GUAM POWER AUTHORITY

AMENDMENT NO.: VII

INVITATION TO BID NO.: GPA-062-25

GLORIA B. NELSON PUBLIC SERVICE BUILDING – PHYSICAL ACCESS CONTROL SYSTEM REPLACEMENT (DESIGN – BUILD)

Gloria B. Nelson Public Service Building
Physical Access Control Project - First Floor Plan

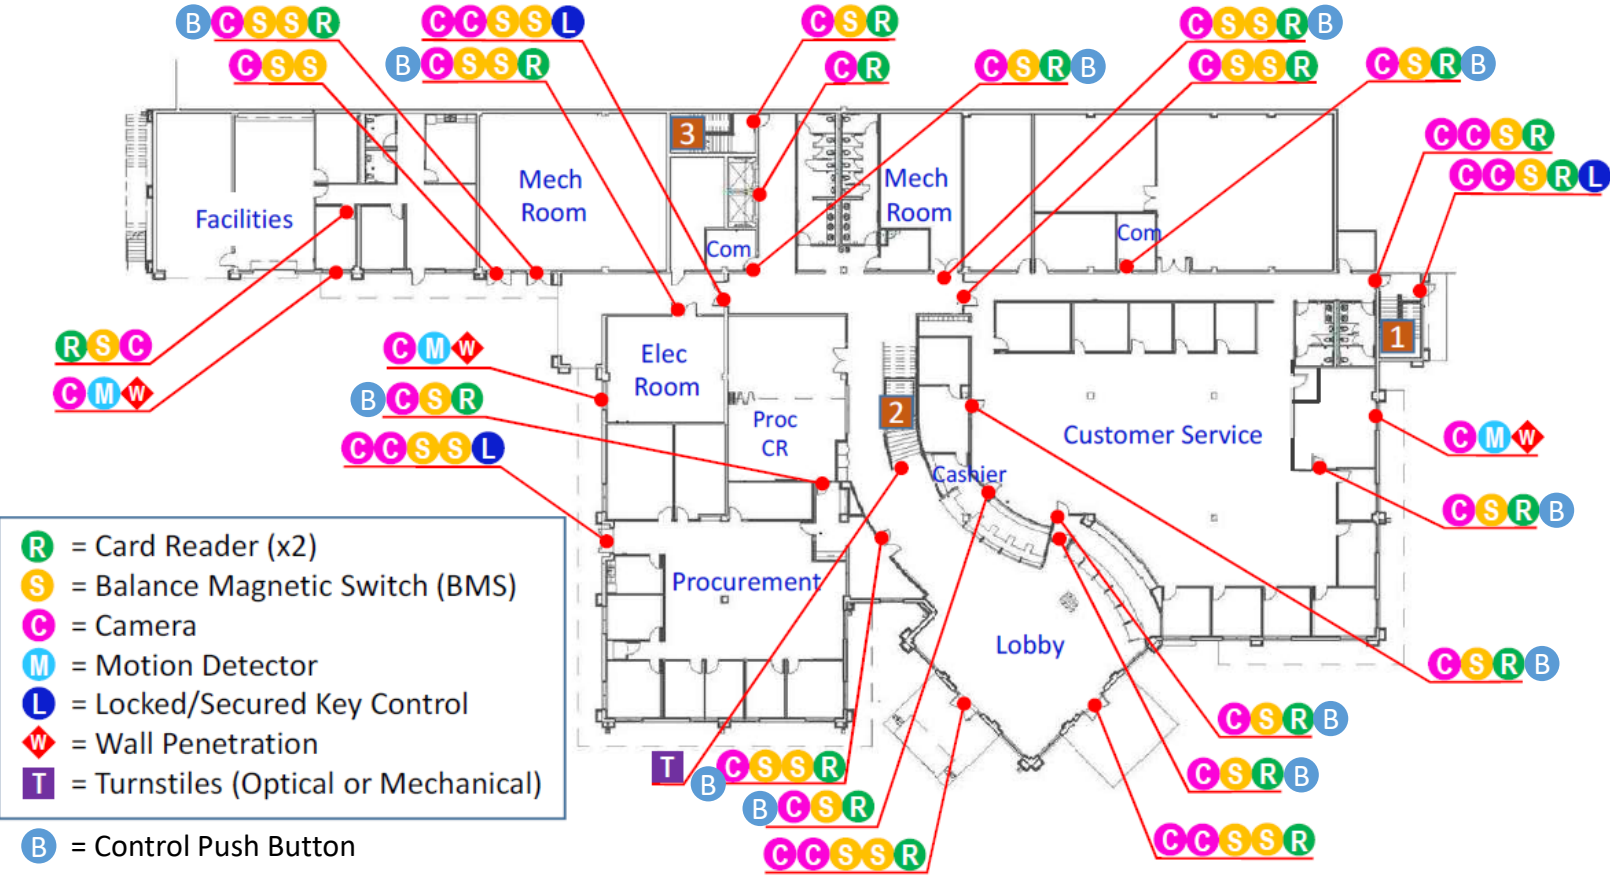
6. **REMOVE** Page 156, 157, 158 and 159 of 166 and **REPLACE** with Page 156a, 157a, 158a, and 159a of 166 (see attached):

Under **FLOOR PLANS**, has changed (see attached)

6. Bid Schedule 2.i:
Please identify the locations of the 25 each alarm Control Push Button and how you want them integrated into the new Access Control System.

Refer to **CHANGE 6** above.
The Floor Plans have been updated to show the doors that warrant Control Push Button.

Cable Tray

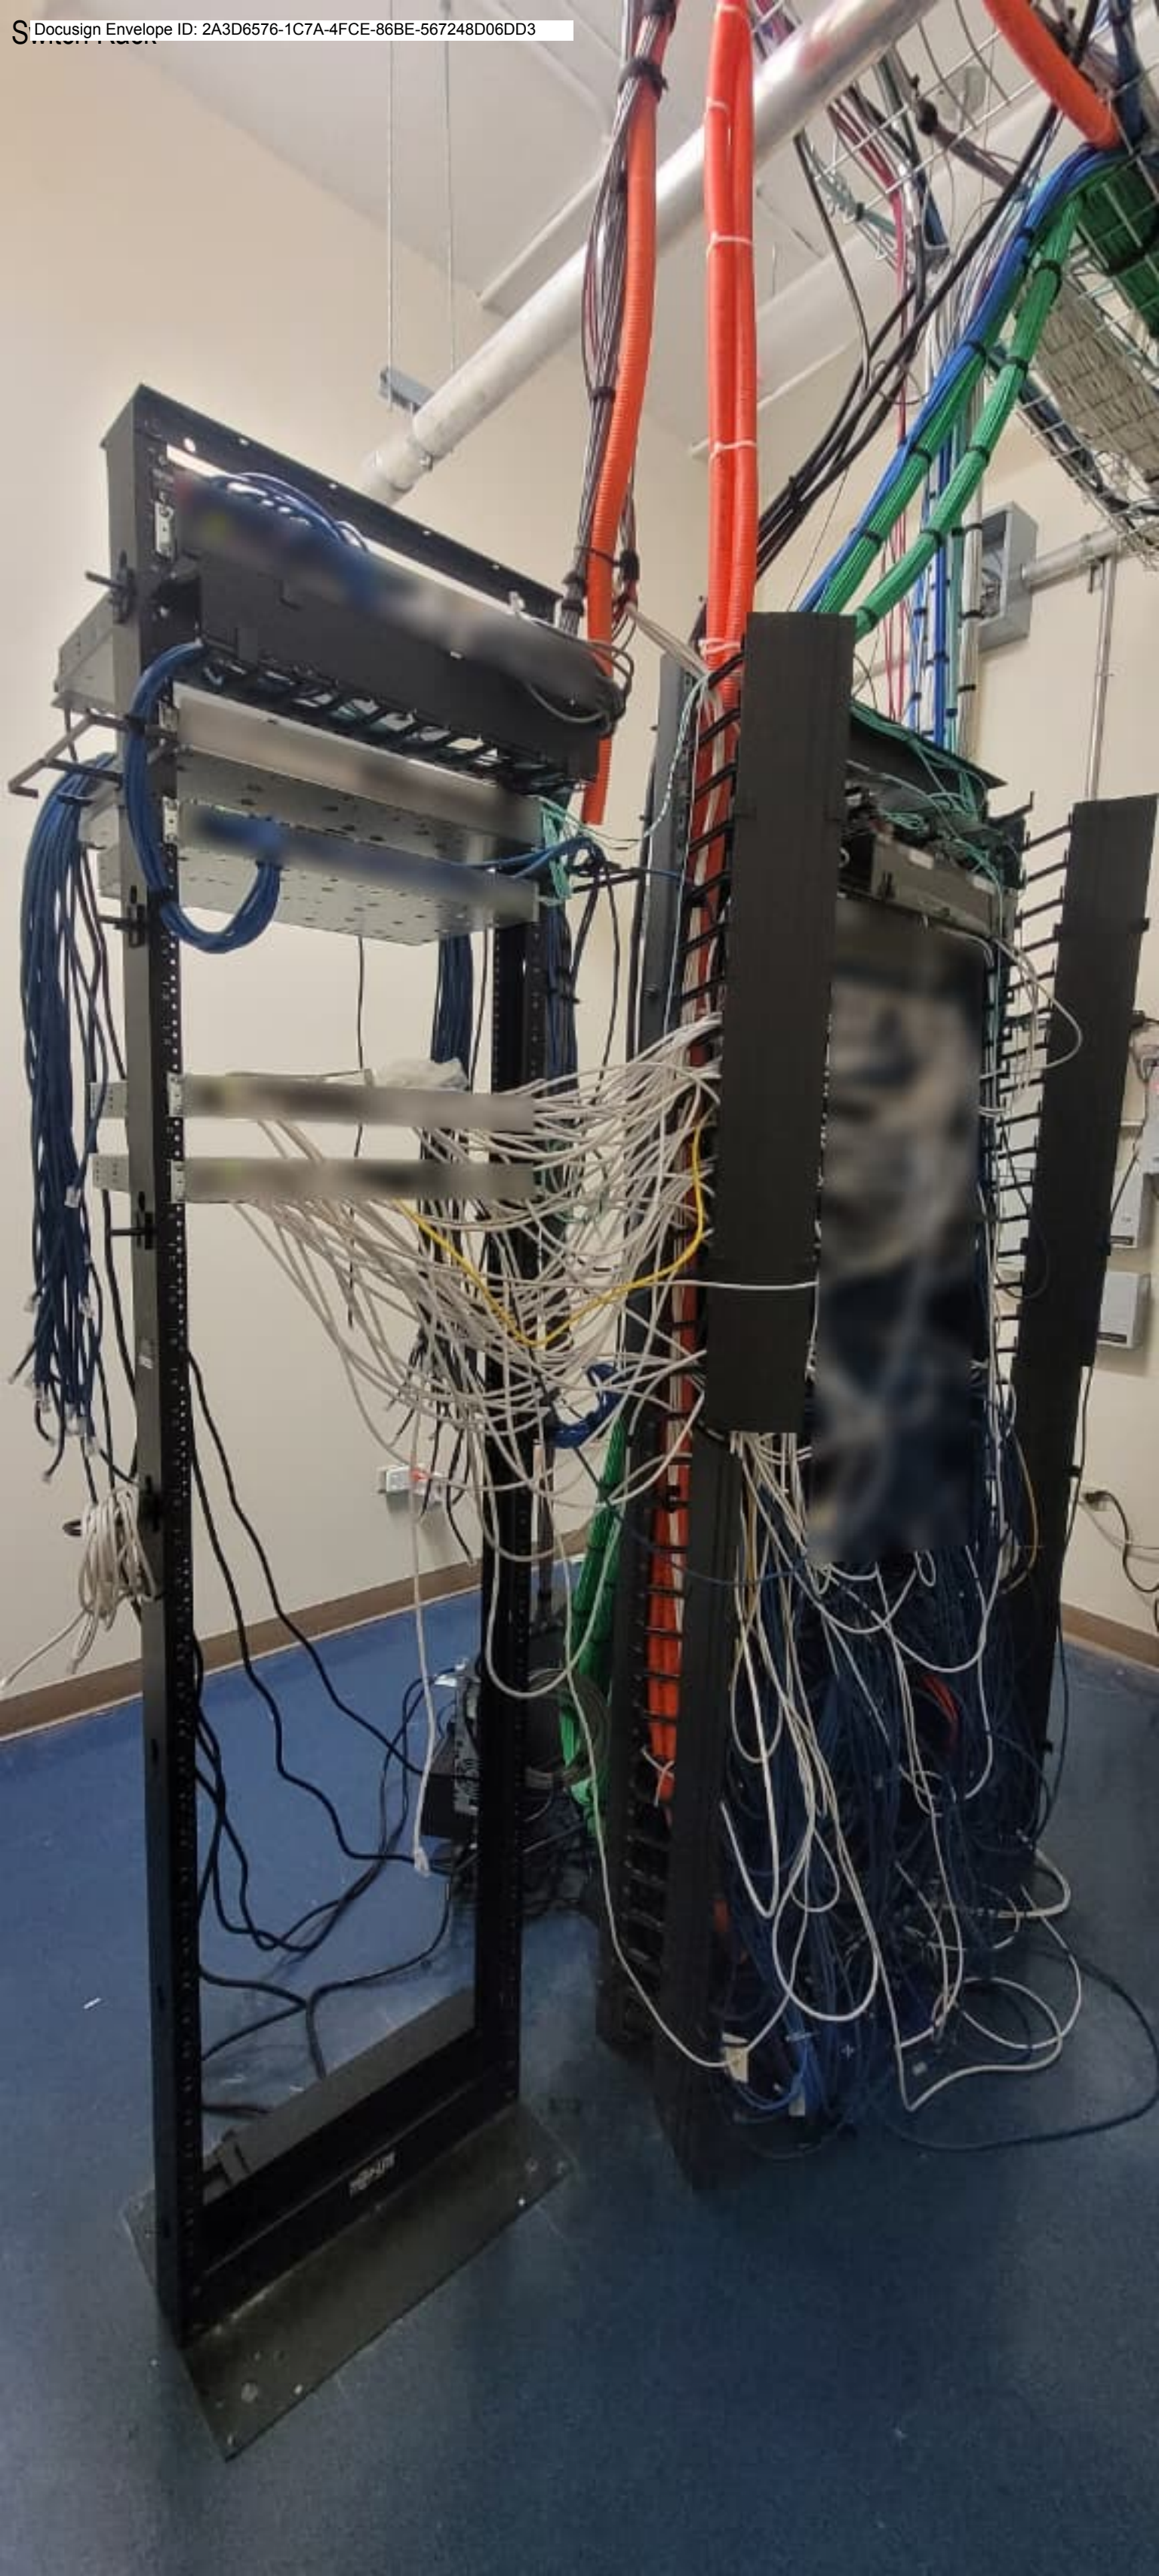
1. Photos of the Communications Rooms (see attached)

- Switch Rack
- Cable Conduit
- Cable Tray

9. Please send us photos of all your COM rooms, emphasizing on the cable trays and the conduits.

6. We are still awaiting the pictures of the Communications Rooms that were requested in a prior RFI.

Refer to **INCLUSIONS** above.

Refer to **INCLUSION** above.

Note: All Communications Rooms in each floor of building are similar in design.
